<u>PROJECT ADDRESS</u>	9603 SE 61ST PL MERCER ISLAND, WA 98040
<u>PROJECT NUMBER</u>	TBD
<u>ASSESSOR'S PARCEL #</u>	4260000020
<u>LEGAL DESCRIPTION</u>	LOT 2 OF LELAND ADDITION, AS PER PLAT RECORDED IN VOLUME 82 OF PLAT, PAGE 19, RECORDS OF KING COUNTY AUDITOR; SITUATE IN THE CITY OF MERCER ISLAND, COUNTY OF KING, STATE OF WASHINGTON.
<u>PROJECT DESCRIPTION</u>	SCOPE INCLUDES A MAIN FLOOR ADDITION (173.53 SF) AND UPPER LEVEL ADDITIONS (493.71 SF) TO EXISTING SINGLE-FAMILY HOME, INCLUDING INTERIOR ALTERATIONS PER PLAN. IN ADDITION, NEW 198 SF DETACHED MODULAR SHED TO BE ADDED PER PLAN.
<u>ZONE</u>	R-15
<u>BUILDING TYPE</u>	SINGLE FAMILY RESIDENCE

During the course of construction, extensive framing rot was encountered and a few alterations were made as a result of the need to re-frame those areas. We are proposing to alter the STAR atrium roof framing from a Gable to shed as part of the rebuild. The new roof form will be lower than the proposed building height as previously permitted and below the MAX allowable building height. Additional changes that occurred as a result of demo discovery and rot repair are using closed cell insulation throughout the roof cavity, new siding scope

A303

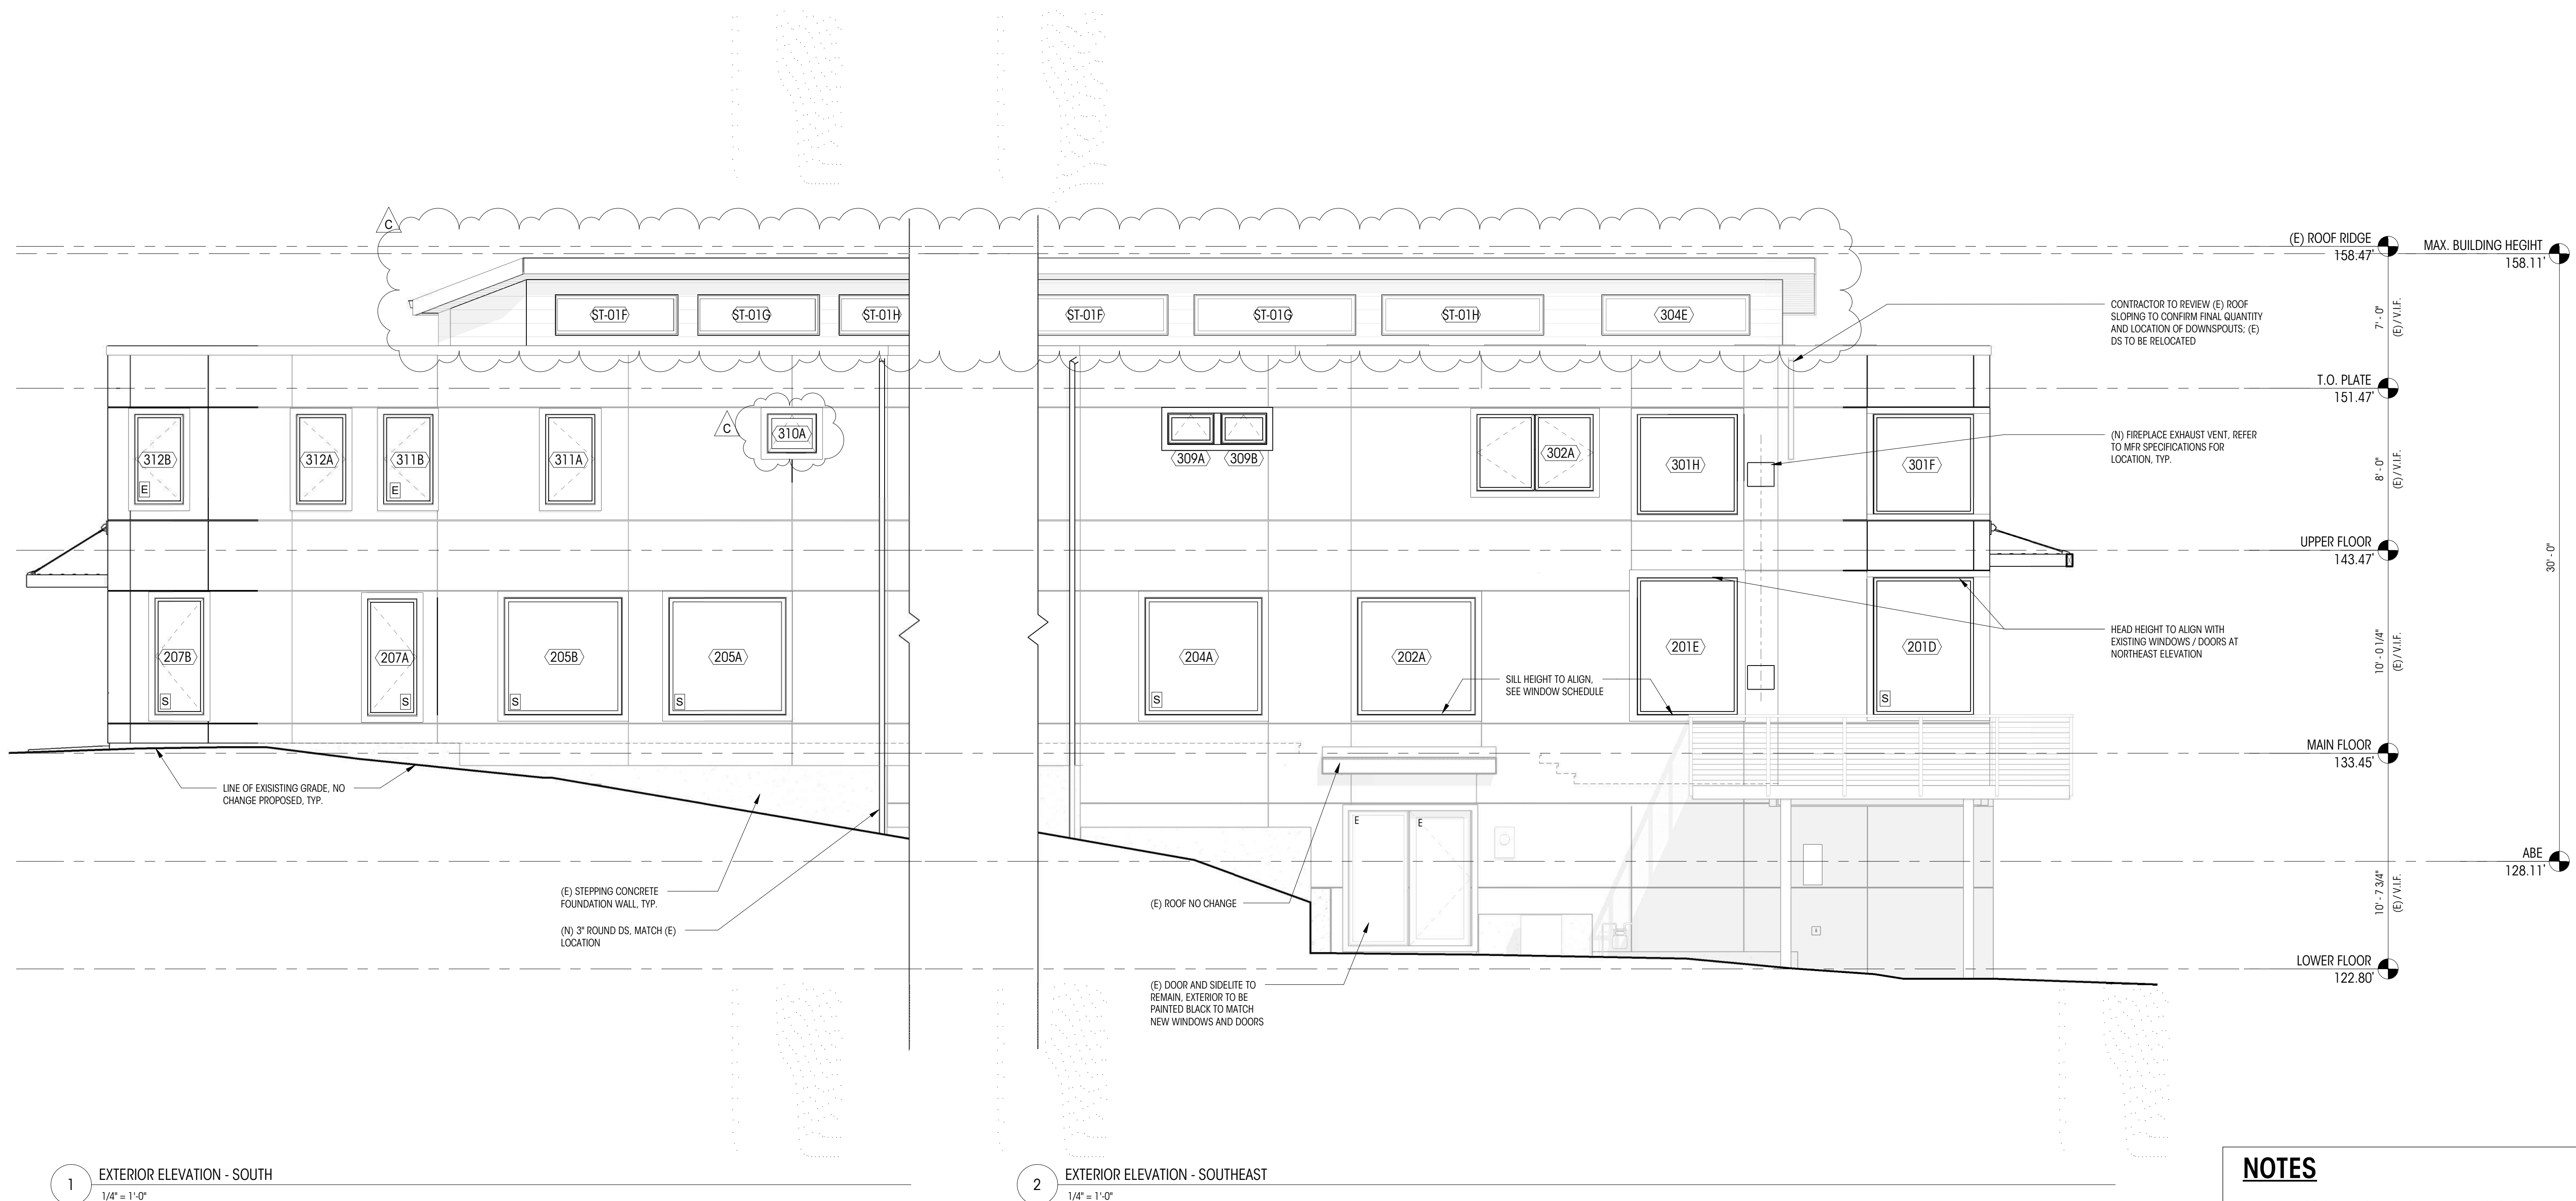
- EXISTING ROOF TO BE REMOVED DUE TO DAMAGE FROM ROOF ROT. NEW ROOF TO BE INSTALLED BELOW THE MAX. BUILDING HEIGHT, WITH NO PROPOSED CHANGE TO LOT COVERAGE OR HARDSCAPE.
- WALL ROT; EXISTING SIDING, SUBSTRATE AND FRAMING TO BE REMOVED AND REPLACED IN PLACE. GC TO VERIFY EXTENTS OF DAMAGE.
- WINDOWS ST-01F-H AT (E) STAIR ST-01 AND 304E AT OFFICE 304 ADDED.
- WINDOW ADJUSTED AT (E) BATH 310 DUE TO EXISTING FRAMING ROT.

A402

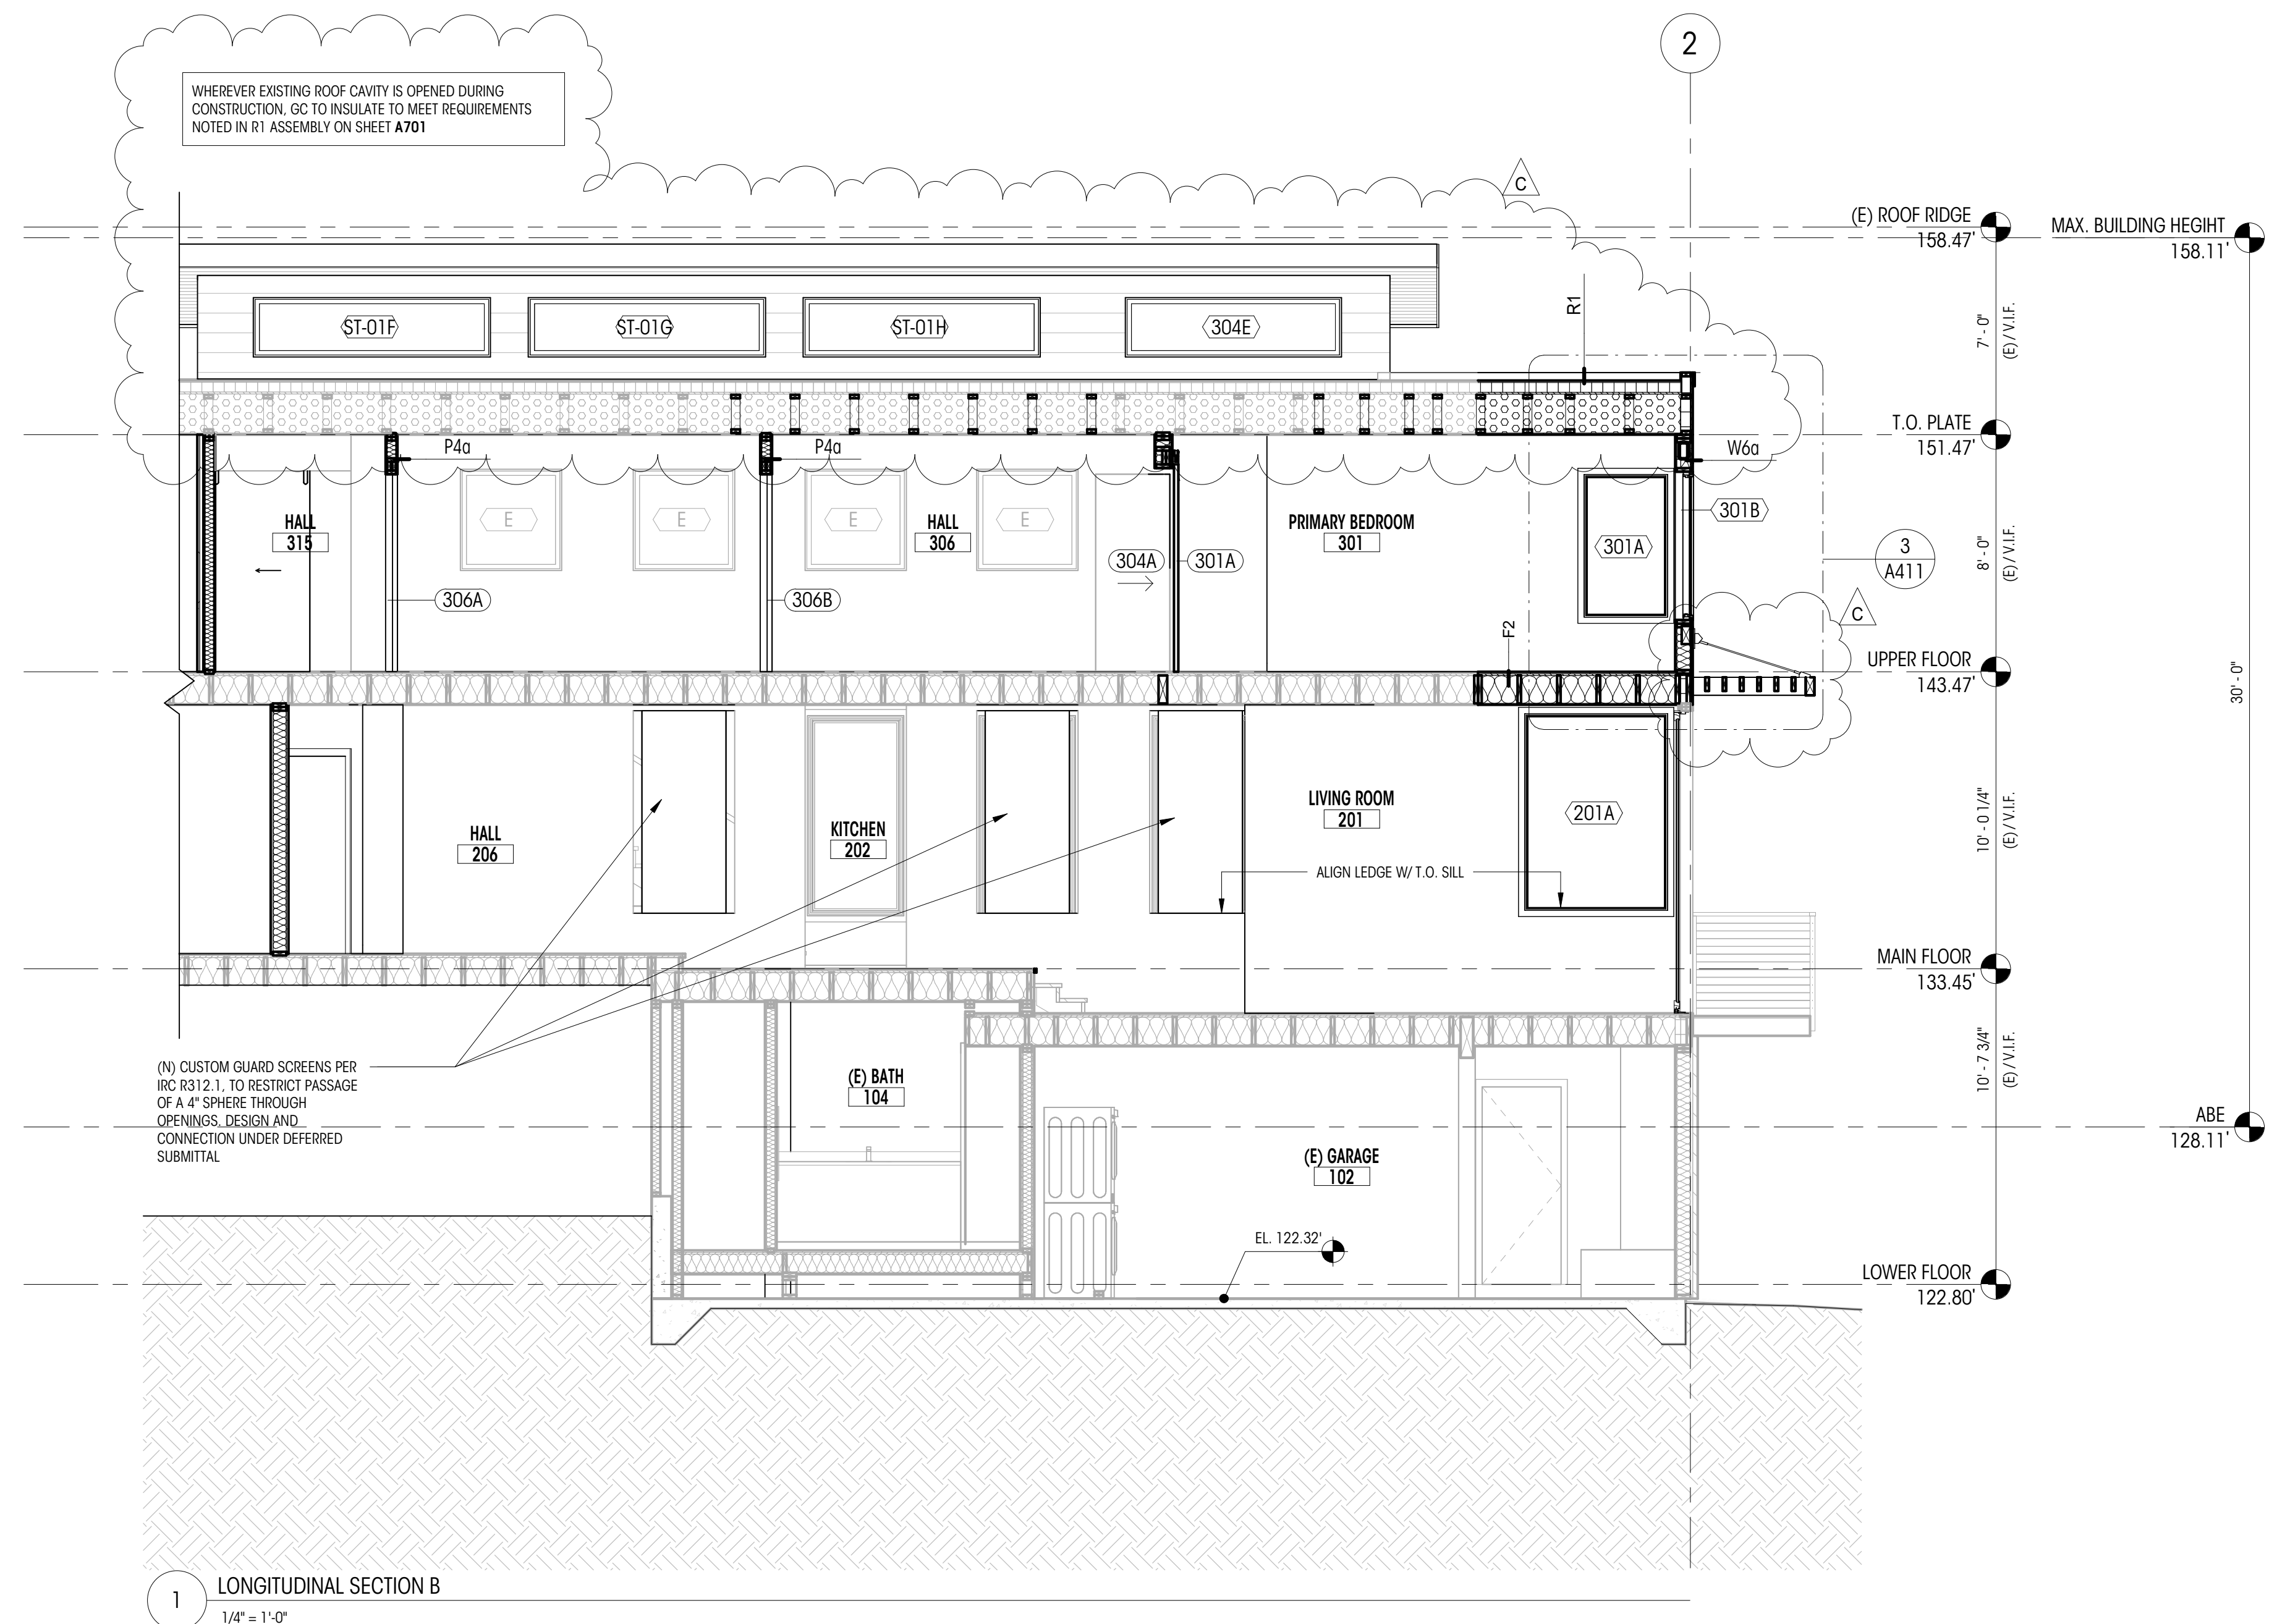
- EXISTING ROOF TO BE REMOVED DUE TO DAMAGE FROM ROOF ROT. NEW ROOF TO BE INSTALLED BELOW THE MAX. BUILDING HEIGHT, WITH NO PROPOSED CHANGE TO LOT COVERAGE OR HARDSCAPE
- WINDOWS ST-01F-H AT (E) STAIR ST-01 AND 304E AT OFFICE 304 ADDED.
- NEW ROOF AREAS TO RECEIVE CLOSED CELL INSULATION, NO VENTING PROPOSED. SEE A701 FOR ROOF ASSEMBLIES
- PERMITTED CANOPY CHANGED TO TRELLIS. NO CHANGE TO LOT COVERAGE OR HARDSCAPE CALCULATIONS

2 TRANVERSE SECTION B
1/4" = 1'-0"1 TRANVERSE SECTION A
1/4" = 1'-0"

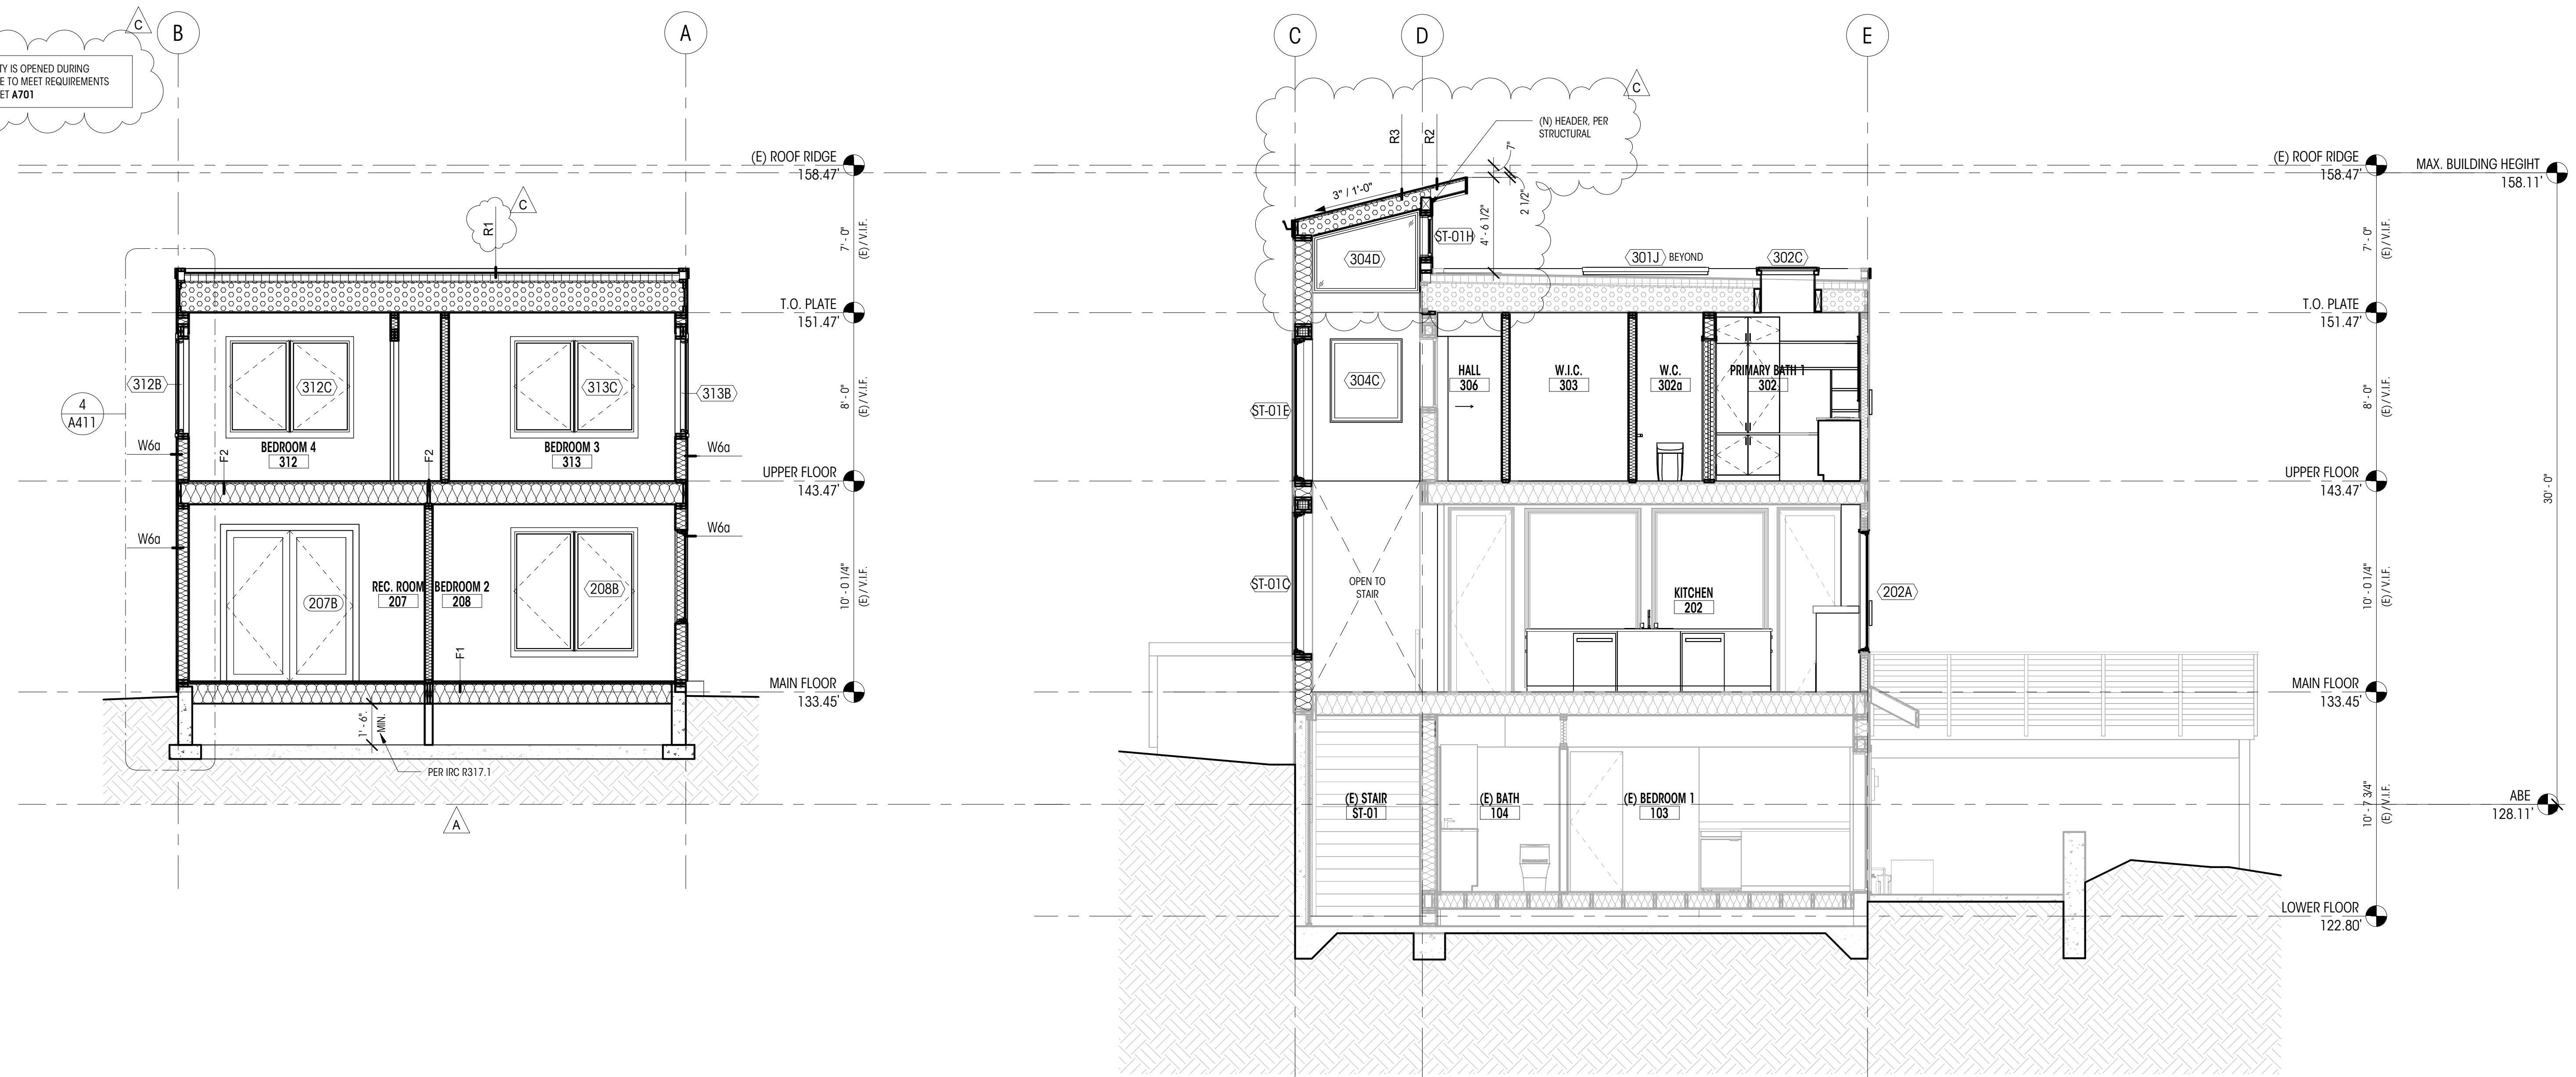
- EXISTING ROOF TO BE REMOVED DUE TO DAMAGE FROM ROOF ROT. NEW ROOF TO BE INSTALLED BELOW THE MAX. BUILDING HEIGHT, WITH NO PROPOSED CHANGE TO LOT COVERAGE OR HARDSCAPE.
- PERMITTED WINDOW 304C CHANGED TO 304D AT OFFICE 304
- WINDOWS ST-01A-E AT (E) STAIR ST-01 AND 304B/C AT OFFICE 304 ADDED.
- NEW ROOF AREAS TO RECEIVE CLOSED CELL INSULATION, NO VENTING PROPOSED. SEE A701 FOR ROOF ASSEMBLIES

WHEREVER EXISTING ROOF CAVITY IS OPENED DURING CONSTRUCTION, GC TO INSULATE TO MEET REQUIREMENTS NOTED IN R1 ASSEMBLY ON SHEET A701
